FIELD SERVICE BULLETIN

FSB Number: LVCCFSB2003-99 (Rev. A)
Author: Tony Bryan
Date: October 17, 2003
Total No. of Pages: 4
Subject: **Triplets Display Flex Connector**
Model Affected: V300, V303, V400, V500, V525
Level of Repair: 2

Diagram 1.0 Poron Pad Placement

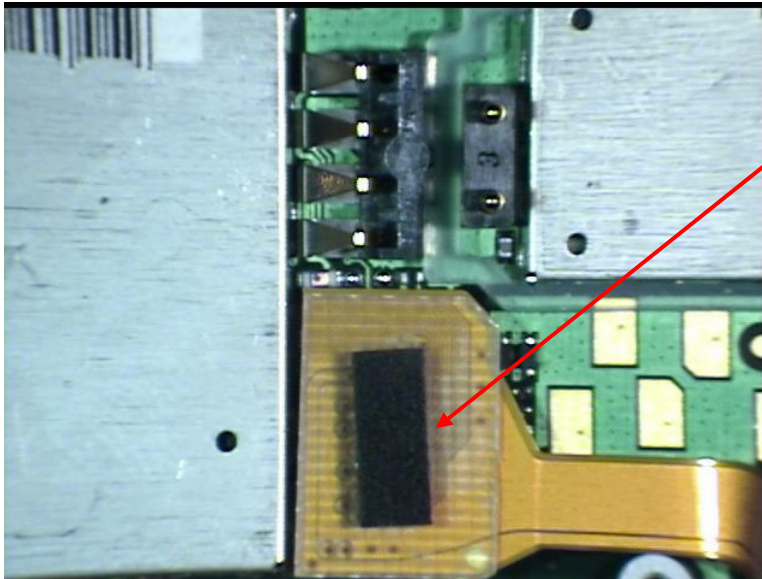
Service is aware of an issue with the Display Flex Connector on GSM Triplets Products. Various electrical failures, seen in ALT Testing after Drop Test, have been linked to a connectivity issue between the Display Assembly and the PCB at the J1300 connector. Failures are seen when the Display Flex becomes partially or completely separated from the J1300 connector.

Manufacturing implemented the placement of a Poron Pad (7589188N01) directly on top and centered on the Display Flex at the connector. The added Poron Pad increases the pressure applied to the connector when assembled and reduces the chances of the Display Flex separating from the J1300 connector in the field. Diagram 1.0 below shows placement of the Poron Pad.

Special Note:
Poron Pad should be placed centered across the top of the Display Flex at the connector

Diagram 2.0 New Rev. E SIM Chassis Design

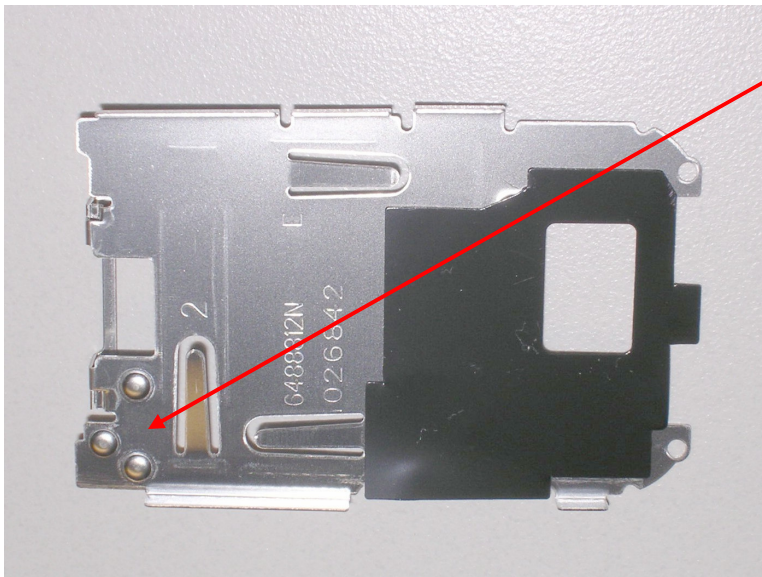
A re-design of the original metal SIM Chassis (0188940N01) has been implemented in production as of 1/26/2004. The new (0188940N02) Rev. E design includes three dented areas that extend further into the housing to add the appropriate amount of pressure to the connector to eliminate this type of failure. Placement of the Poron Pad is not compatible with the new (0188940N02) Rev. E SIM Chassis.

Diagram 2.0 below shows a sample of the new (0188940N02) Rev. E SIM Chassis with the improved design.

Special Note:
New Design with Three Dented Areas to apply pressure to connector

1. Disassemble the unit
2. Verify the Display Flex is properly seated in the J1300 connector and repair if necessary
3. Remove the existing Poron Pad from the Flip Assembly Connector
4. Replace the existing metal SIM Chassis with the improved Rev. E Design
5. Reassemble and Relabel unit
6. Perform all necessary testing to ensure the units has been successfully repaired.
 - a. If unit continues to exhibit the original symptoms, then proceed with normal troubleshooting techniques as per the customer's complaint.

Existing inventory of the original Rev. A Design (0188940N01) Sim Chassis should be removed and replaced with the improved (0188940N02) Rev. E Design.
